# PRODUCT ADVISORY NOTICE

**Subject:** 2D Barcode Added to Rotary Switches

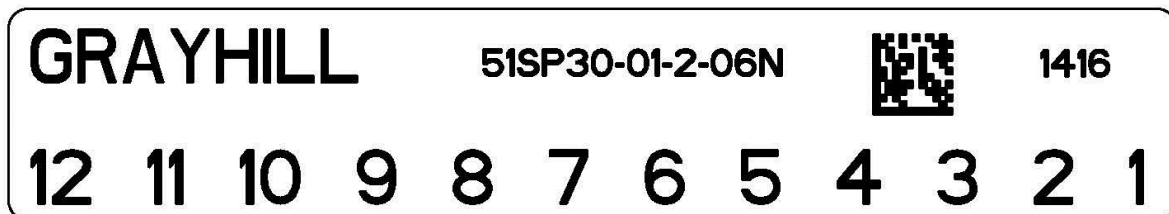
A 2D barcode will be added to the label that is applied to each rotary switch. This barcode will contain a 4 digit date code and a 5 digit serial number. A representative sample of the new label is shown below. No changes will be made to the human readable information that appears on the label.
